COMMITTEE OF THE WHOLE MARCH 3, 2003

**ZONING BY-LAW AMENDMENT FILE Z.03.011
SITE DEVELOPMENT FILE DA.02.061
ALTERRA-FINER SPACE LIMITED**

Site Plan

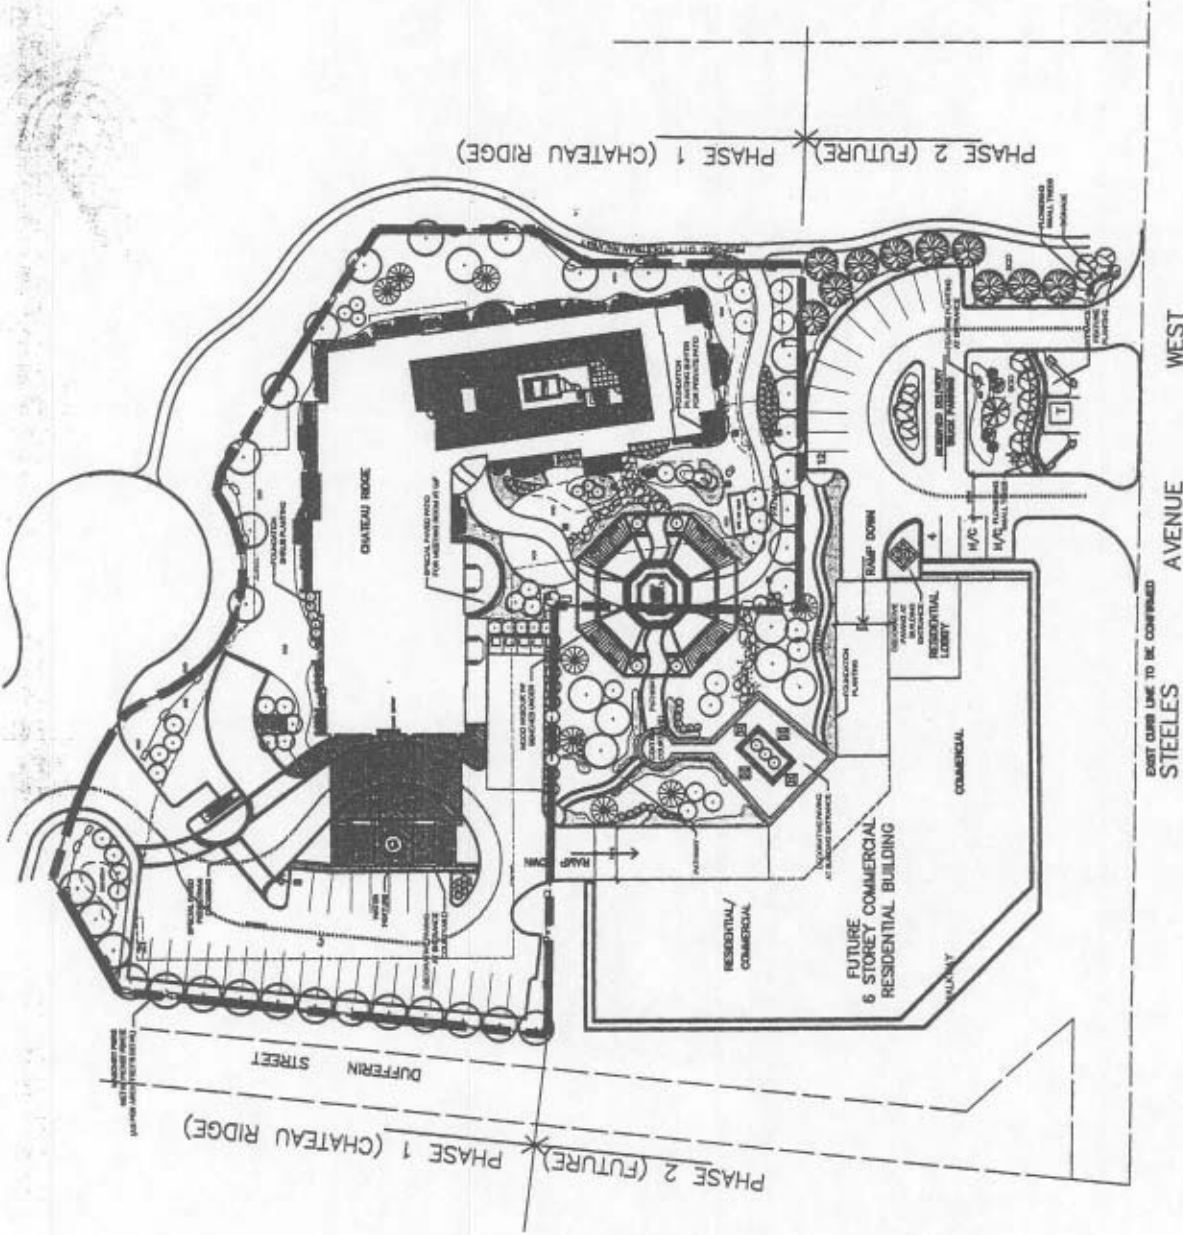
- the site plan is to show the location of the barrier-free parking space, including signage detail, and shall be dimensioned to show aisle widths, parking space size, and access widths;
- the end-aisle offsets for the at-grade and underground parking areas shall be increased to 1.5m for manoeuvrability;
- the underground parking plan shall be dimensioned to show aisle widths, parking space size, and access widths; and,
- the vehicle access point on Dufferin Street shall be approved by the Region of York.

Vehicle and pedestrian access and site circulation shall be to the satisfaction of the Engineering Department and the York Region Transportation and Works Department.

Phase 2 - Conceptual Plan

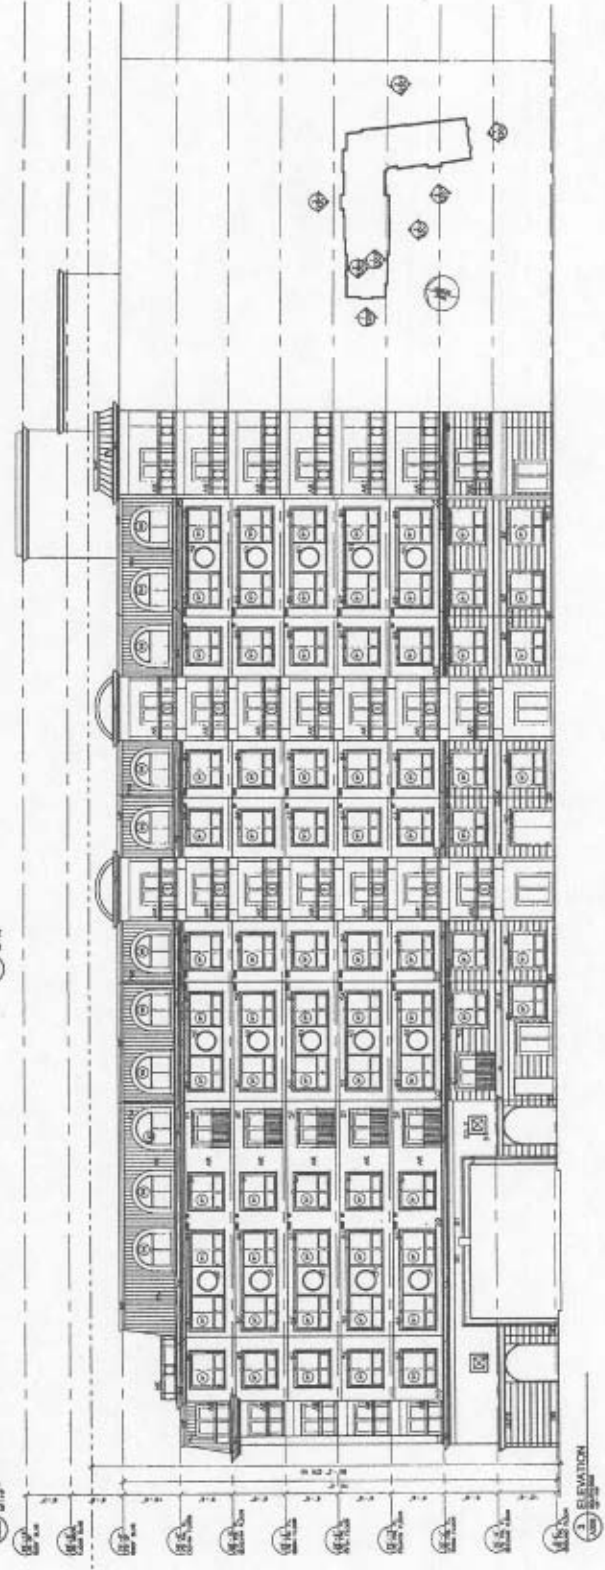
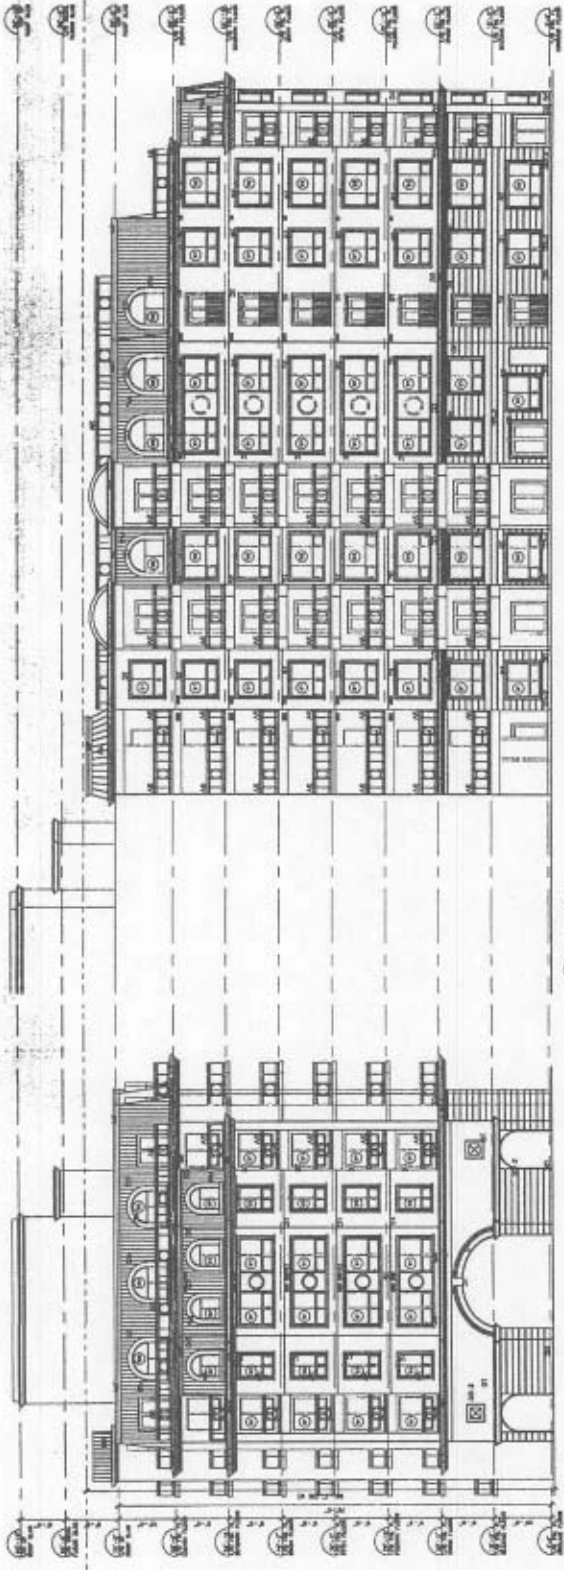
A Phase 2 plan for the lands to the south (Attachment 3), has been submitted to demonstrate proper integration of the future 6-storey apartment with the current site development. Specifically, Staff reviewed the vehicle and pedestrian circulation, landscape requirements and the central courtyard amenity area. Staff is satisfied, in principle, with the phasing details as submitted as a foundation for the Phase 2 application.

It is anticipated that upon construction of the Phase 2 lands, the noise barrier along the south boundary will become redundant with another Phase 2 building buffering Steeles Avenue and Dufferin Street. Phase 2 plan shows a common amenity area between the Phase 1 and 2 buildings which, to be completed, would require removal and/or relocation of the acoustic barrier. A further noise report will be required upon submission of Phase 2 to determine the revised noise abatement requirements.

Accordingly, Staff recommends that the Site Plan Agreement require the Owner/Condominium Corporation to undertake the removal or relocation of the noise wall, if necessary, at no cost to the City, at the time of the construction of Phase 2.

Landscape Plan

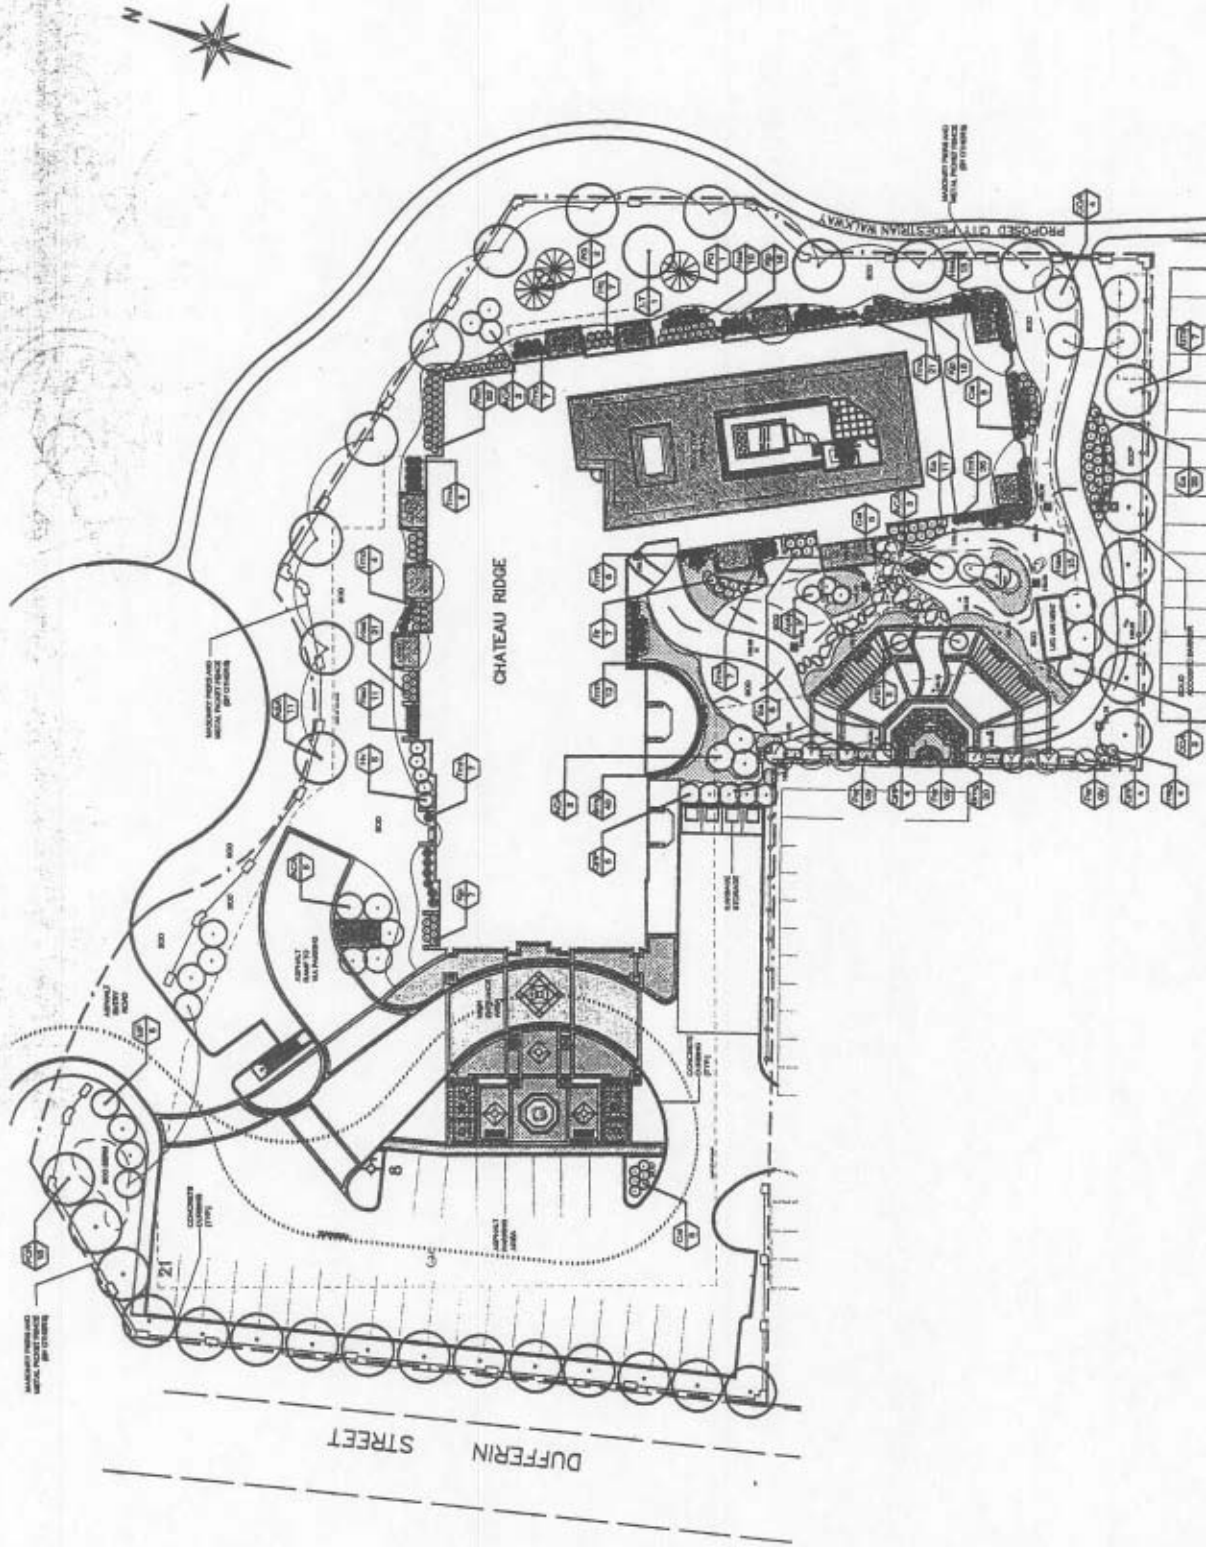
The plan shows a 1.8m high black metal picket fence with masonry piers along the west property line, and a 1.5m high black metal picket fence with masonry piers along the north and east property lines. A 2.3m high solid wood acoustic barrier fence is proposed along the south property line, in accordance with the Noise Impact Study.

The final landscape plan must be to the satisfaction of the Urban Design Department.
